Planning Amendment Refs

Client: Tameside College
Project: Construction Skills Building
Job No.: 1072
Date: 11/29/18
BIM Model: TCCB-10A-ZZ-ZZ-M3-A-0003
QA: PM AS
Scale: As Indicated @ A1
Drawing: Proposed Site Plan
Rev notes: 1162 - Updated Planning Issue

TCCB- 10A- V1- 00- DR- A- 9001-L2

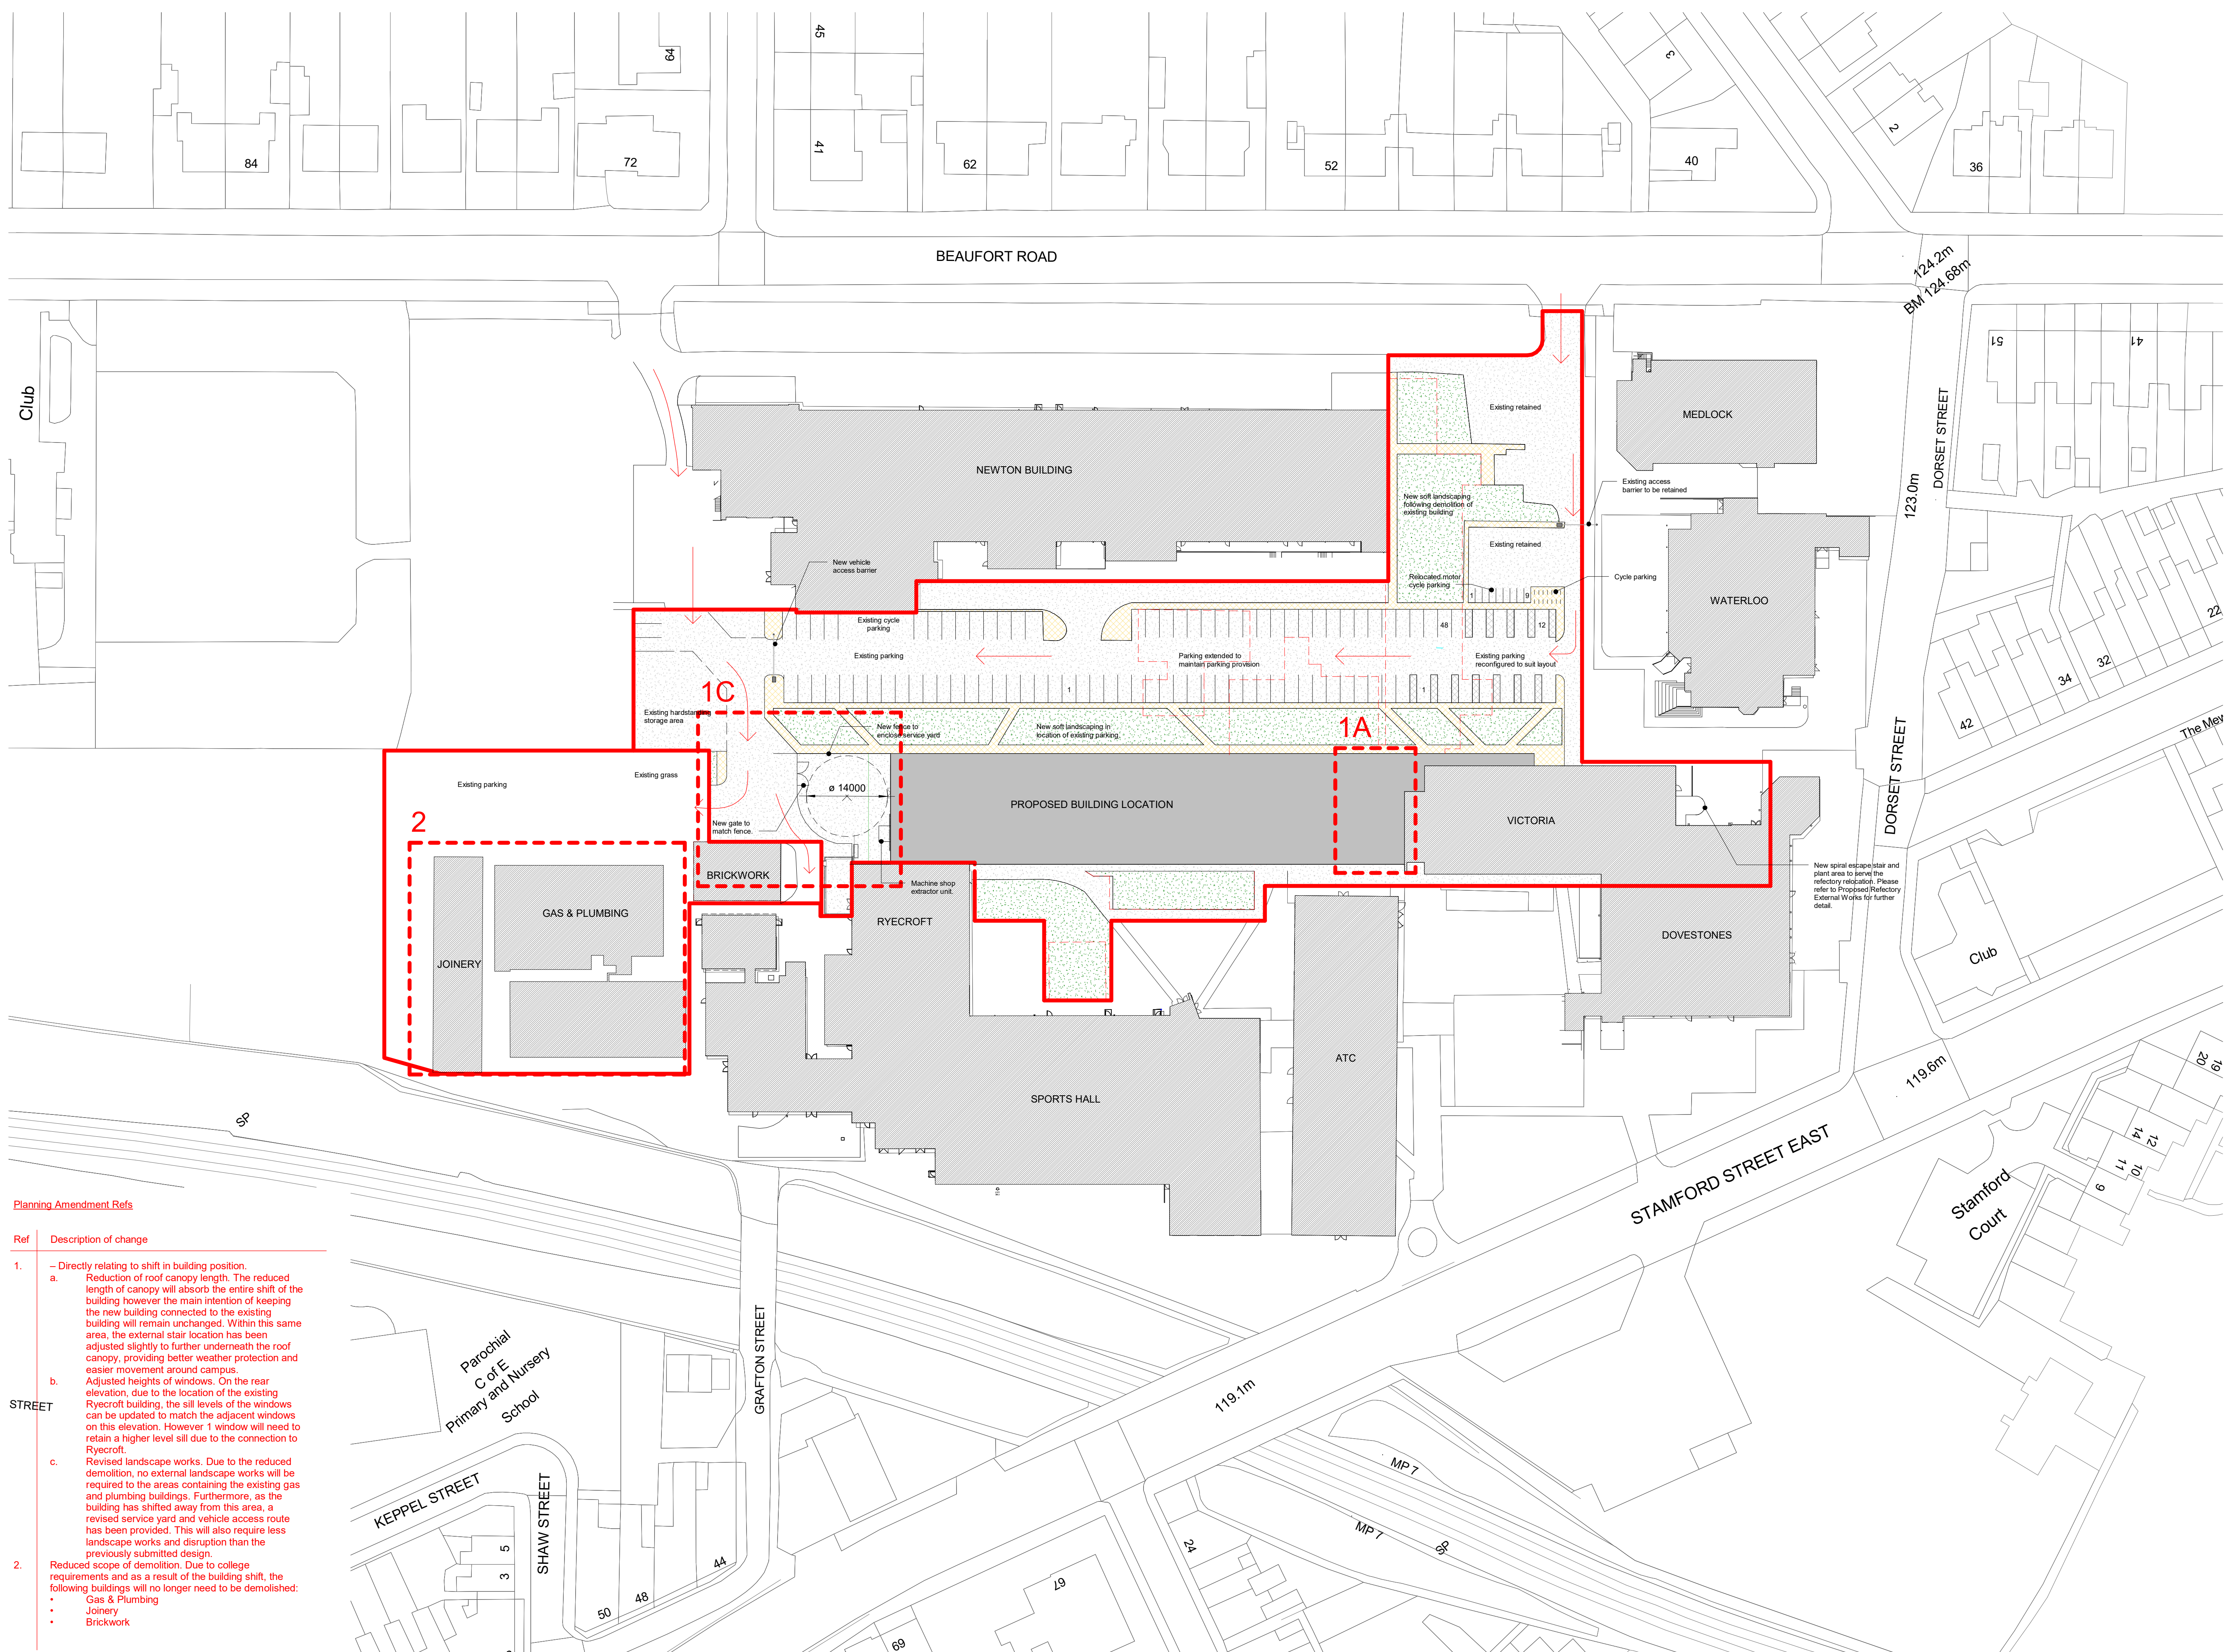
Ref	Description of change
1.	<p>– Directly relating to shift in building position.</p> <p>a. Reduction of roof canopy length. The reduced length of canopy will absorb the entire shift of the building however the main intention of keeping the new building connected to the existing building will remain unchanged. Within this same area, the external stair location has been adjusted slightly to further underneath the roof canopy, providing better weather protection and easier movement around campus.</p> <p>b. Adjusted heights of windows. On the rear elevation, due to the location of the existing Ryecroft building, the sill levels of the windows can be updated to match the adjacent windows on this elevation. However, this window will need to retain a higher level sill due to the connection to Ryecroft.</p> <p>c. Revised landscape works. Due to the reduced demolition, no external landscape works will be required to the areas containing the existing gas and plumbing buildings. Furthermore, as the building has shifted away from this area, a revised service yard and vehicle access route has been provided. This will also require less landscape works and disruption than the previously submitted design.</p>

2.	<p>Reduced scope of demolition. Due to building requirements and as a result of the college shift, the following buildings will no longer need to be demolished:</p> <ul style="list-style-type: none"> • Gas & Plumbing • Joinery • Brickwork
